TRANS/WP.29/GRB/34
12 April 2002

REPORT OF THE WORKING PARTY ON NOISE (GRB) ON ITS THIRTY-SIXTH SESSION

AMENDMENTS TO DOCUMENT TRANS/WP.29/2002/7
ADOPTED BY GRB AT ITS THIRTY-SIXTH SESSION

Item 14., amend to read:

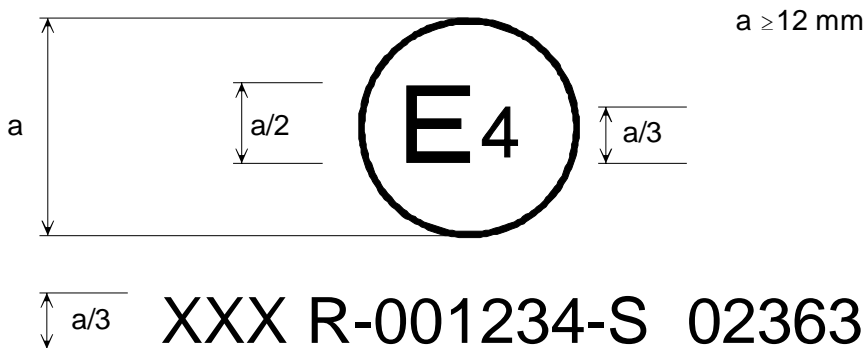
"14. Annexed to this communication are:

14.1. A list of documents in the approval file deposited at the Administration services having delivered the approval and which can be obtained upon request.

14.2. A list of tread-pattern designations: Specify for each trademark or brand name and trade description the list of tyre size designations adding, in the case of Class C1 tyres, the mark "Reinforced" or "Extra Load", if applicable."

"Example 3

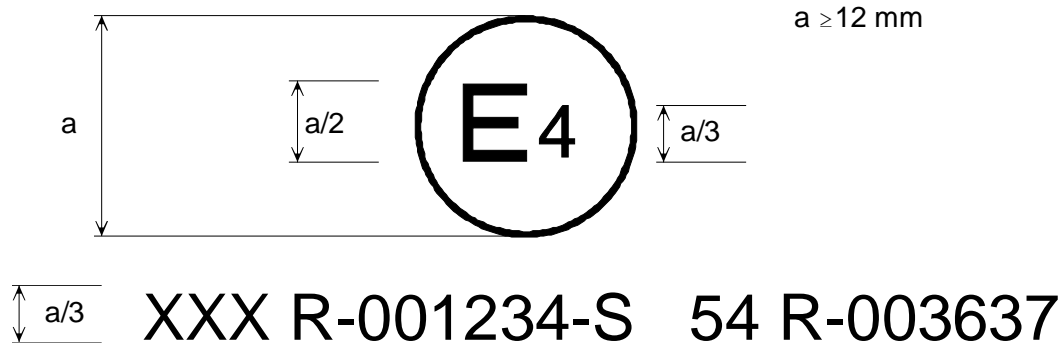
Insert a new example 3, to read:

The above approval mark shows that the tyre concerned has been approved in the Netherlands (E4) pursuant to Regulations Nos. XXX and 54. The first two digits of the approval numbers indicate that, at the dates when the respective approvals were granted, Regulations Nos. XXX and 54 were still in their original form.

Note: The approval number(s) must be placed close to the circle and either above or below the "E" or on the left or right of that letter. The digits of the approval number must be on the same side of the "E" and face in the same direction. The use of Roman numerals as approval numbers should be avoided so as to prevent any confusion with other symbols."
